NORTHERN STATES POWER COMPANY

PRAIRIE ISLAND NUCLEAR GENERATING PLANT
Docket Nos. 50-282 License Nos. DPR-42
50-306 DPR-60

Information Relating to Fire Protection Modifications

Information Relating to Fire Protection Modifications

FIGURE 1

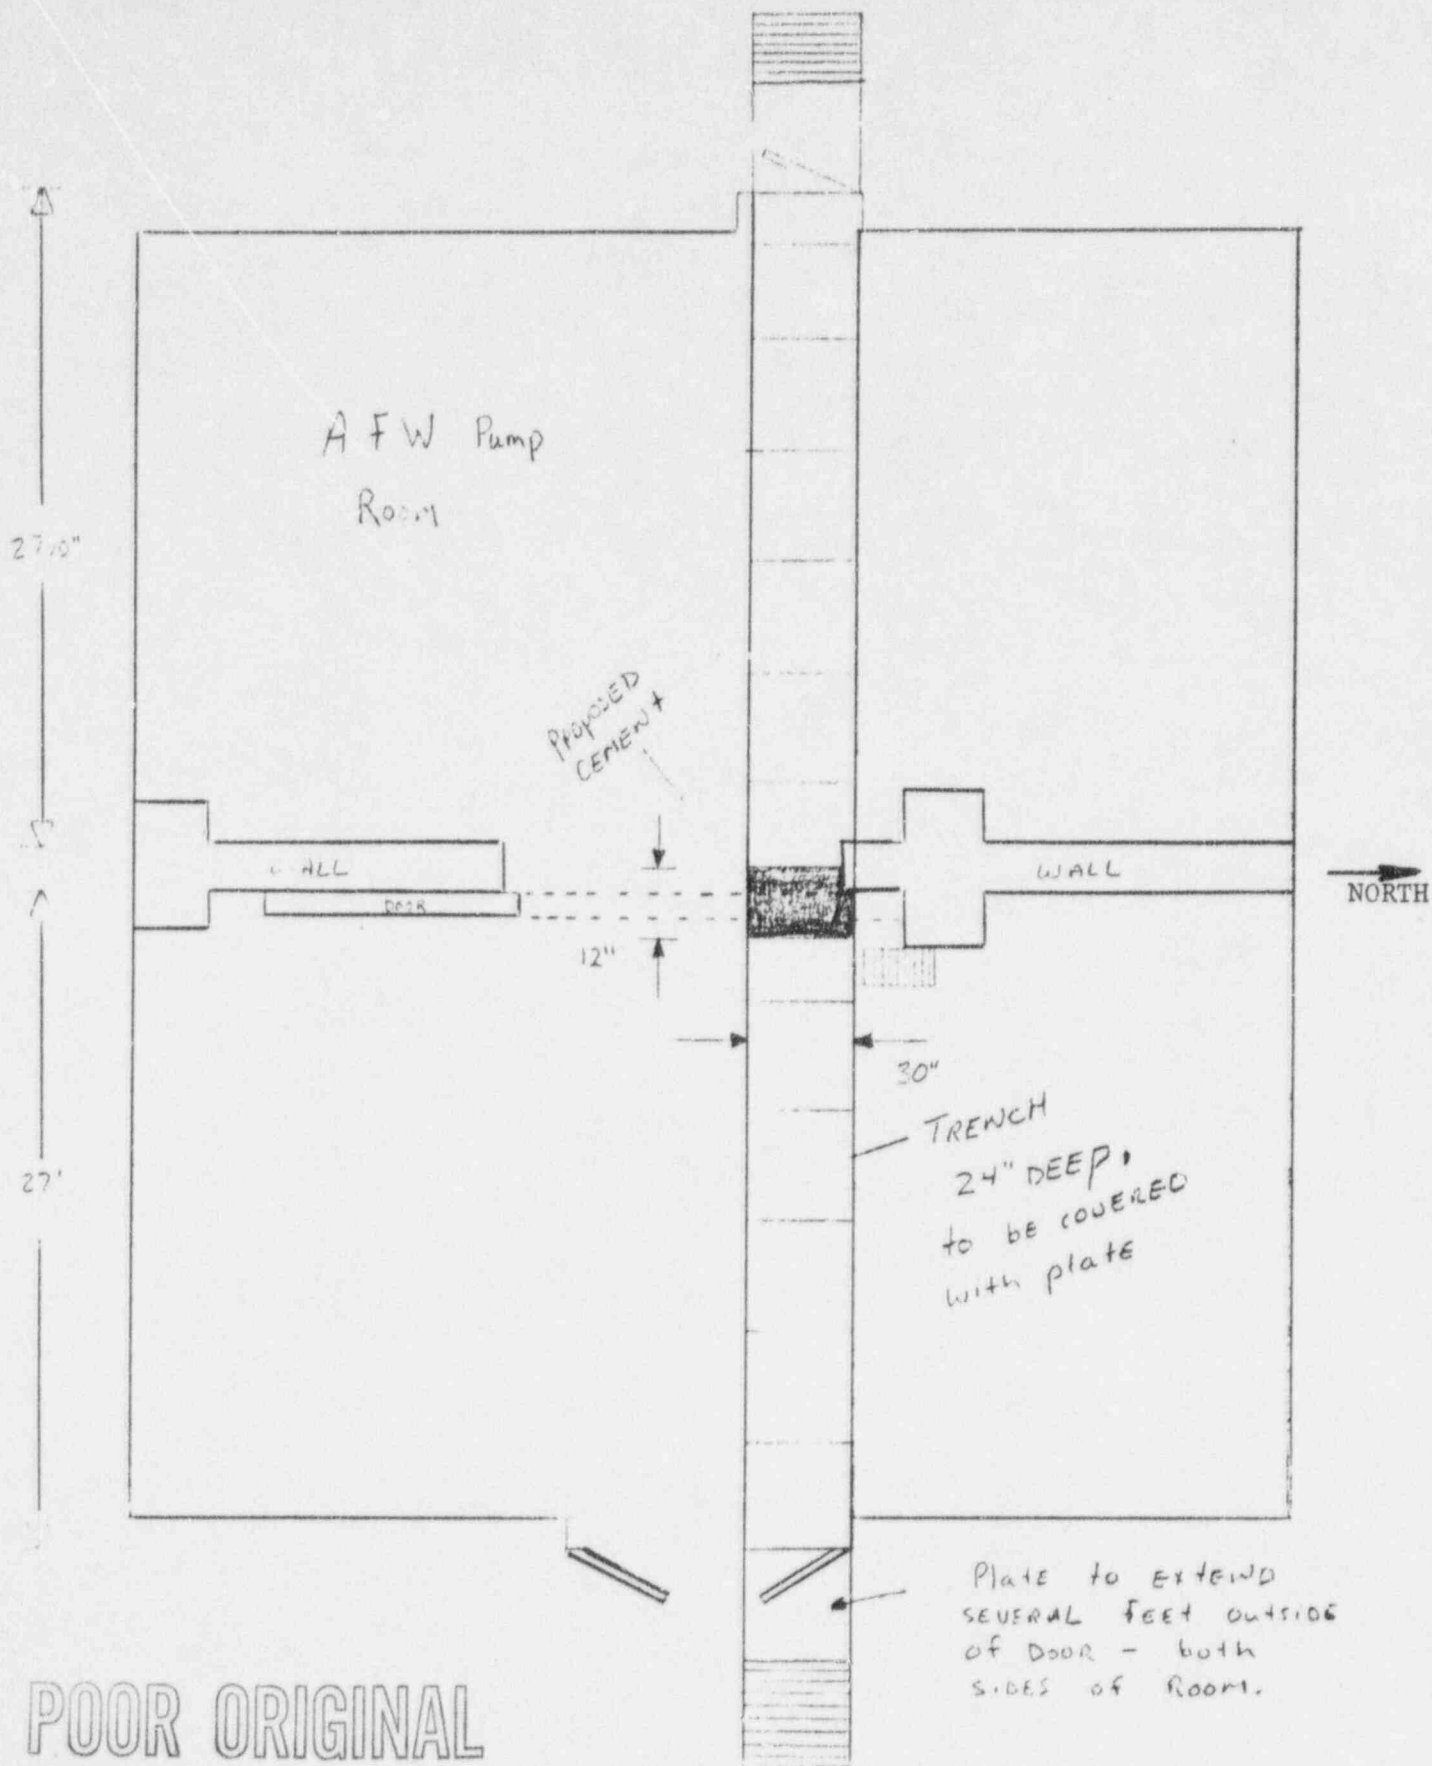
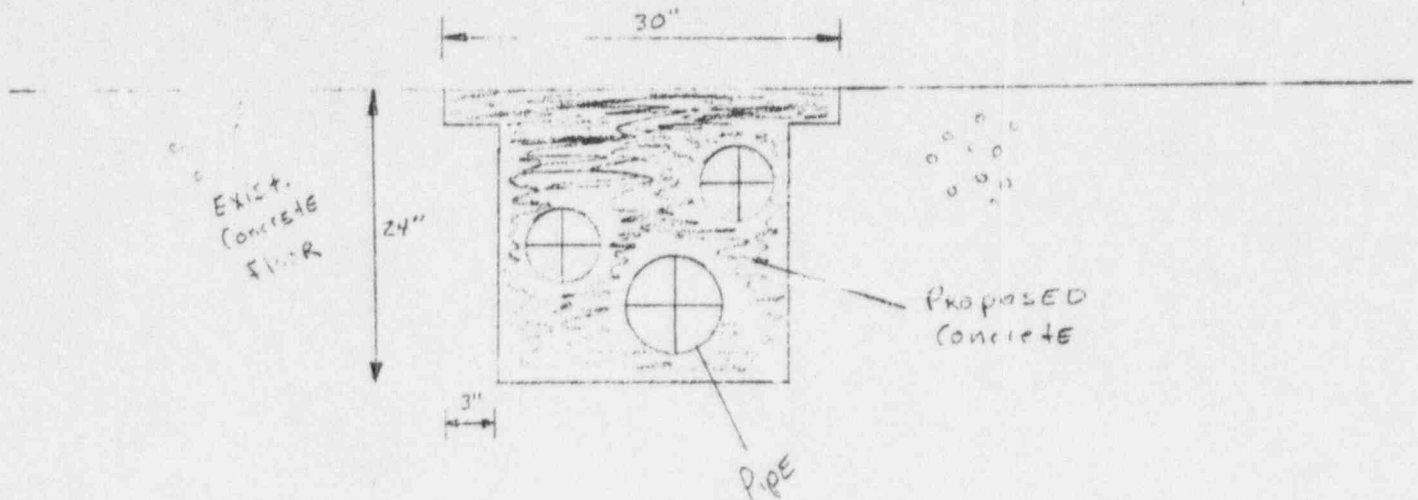
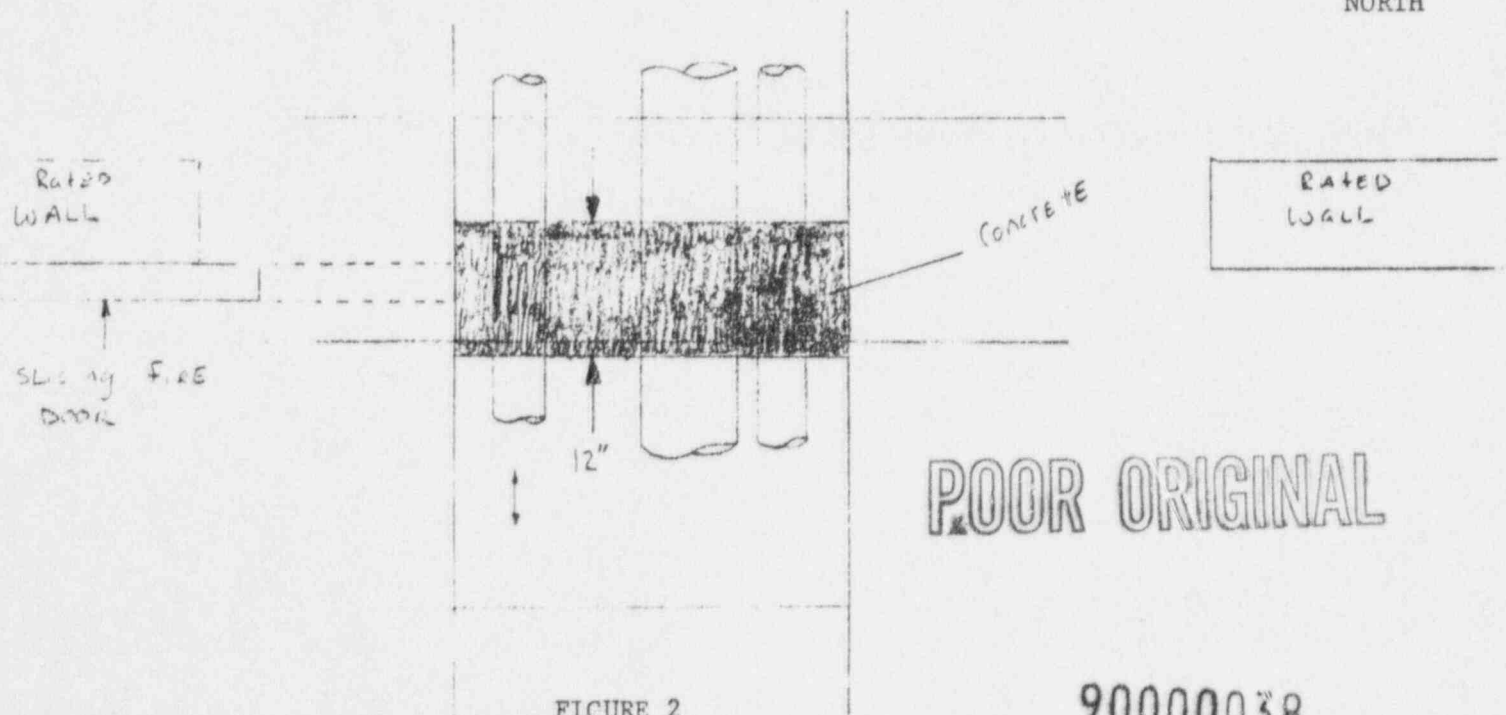
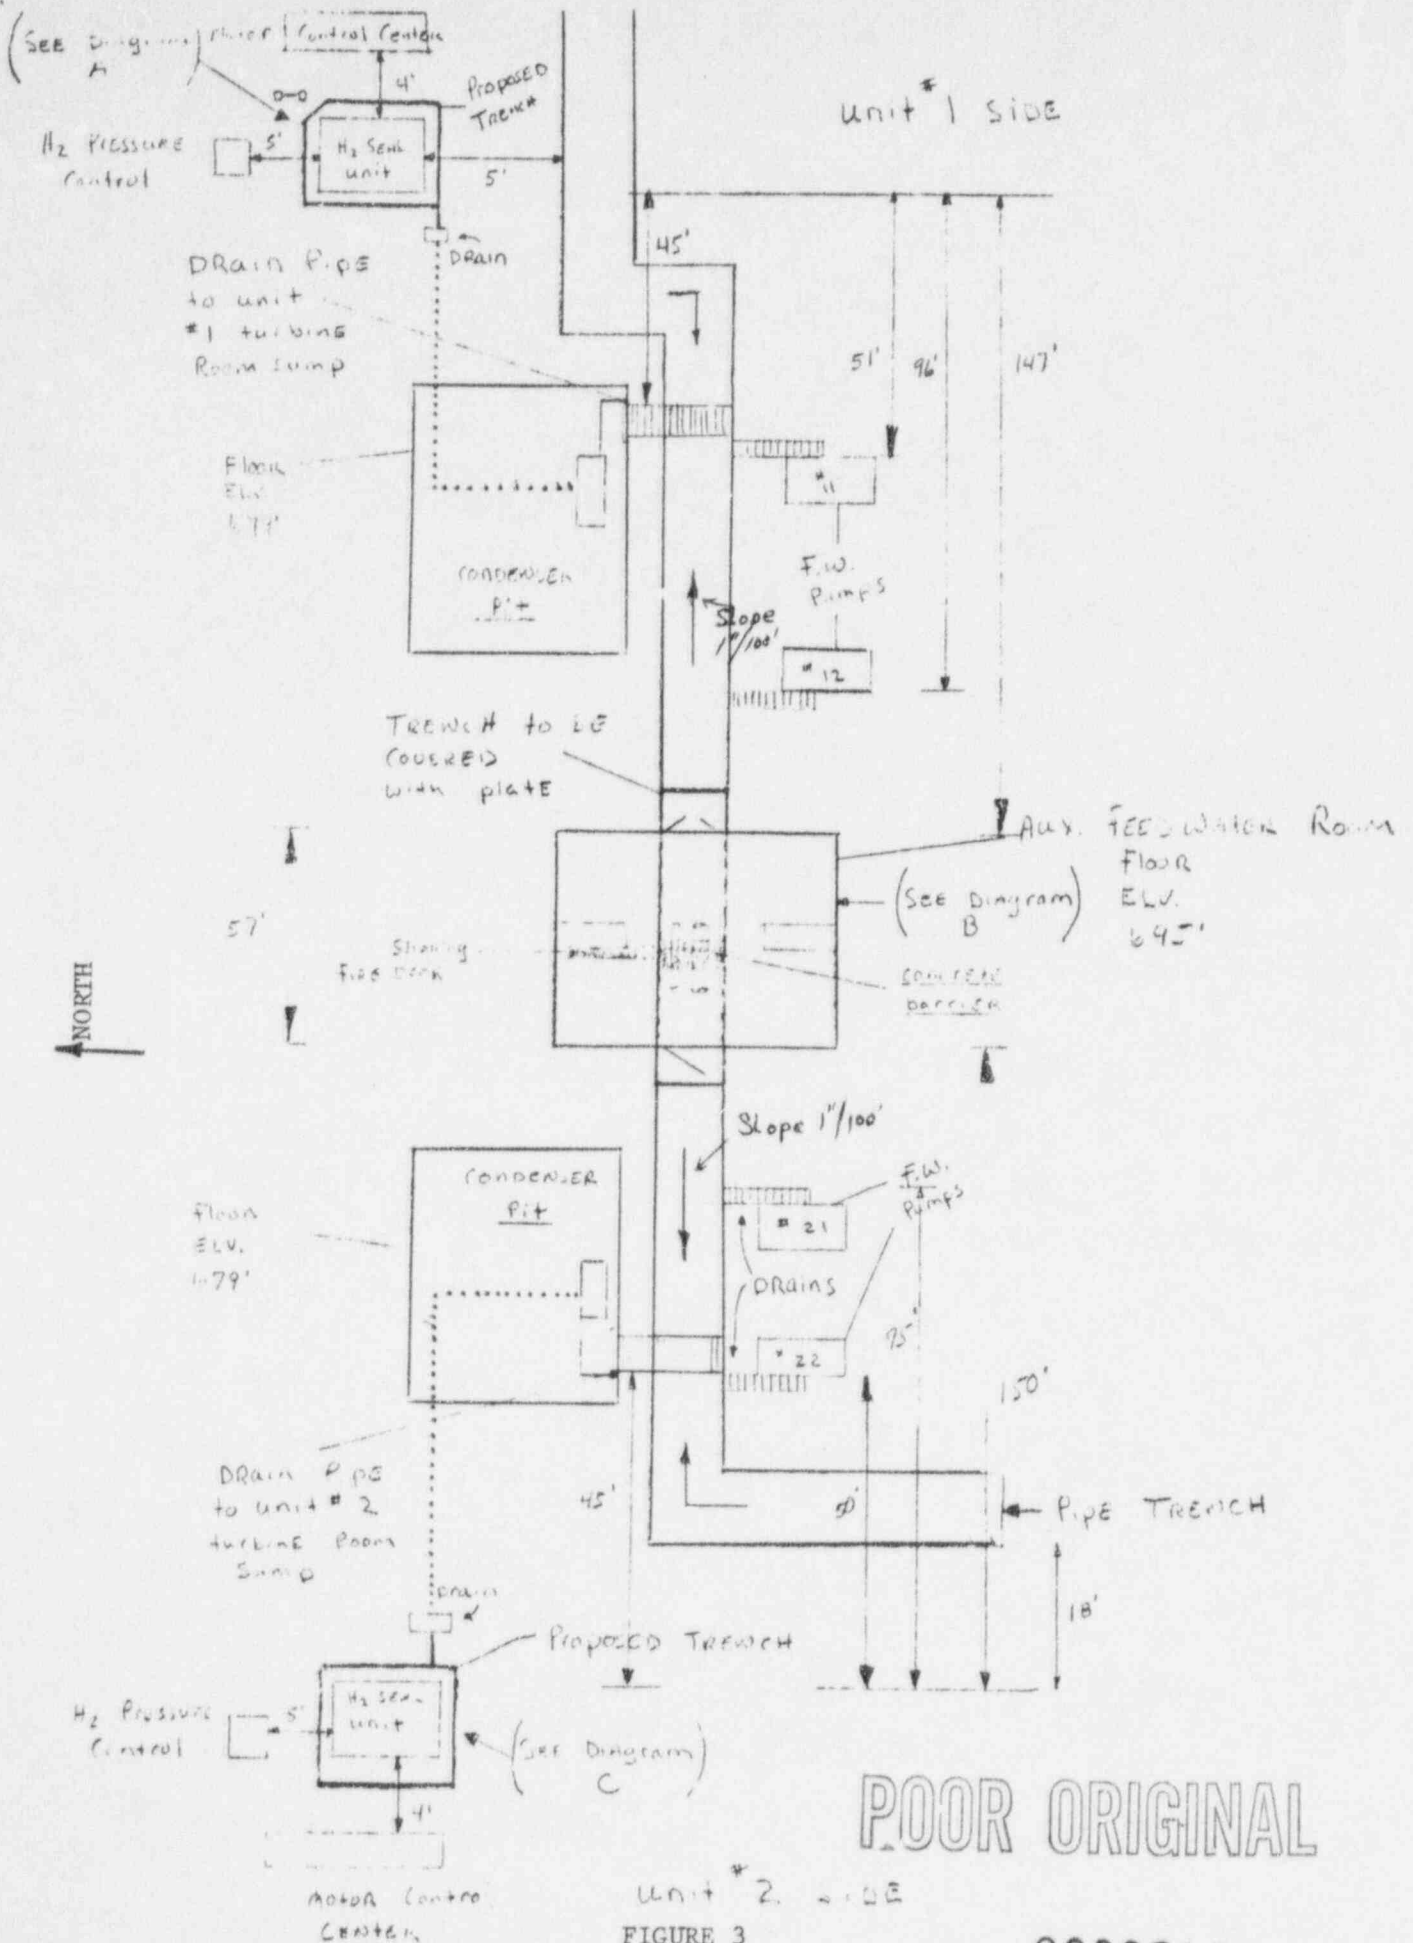
3.1.1 (1) Auxiliary Feed Pump Area Trench Barrier

We propose to pour a 12" thick slab (see Figures 1, 2, and 3) that will be offset from the barrier walls, but will be centered under the sliding fire door. As shown on the figures, the slab will fill the entire trench to floor level.

In addition, the trench grating will be covered with a plate from the slab to a point approximately two feet outside each of the entrance doors.
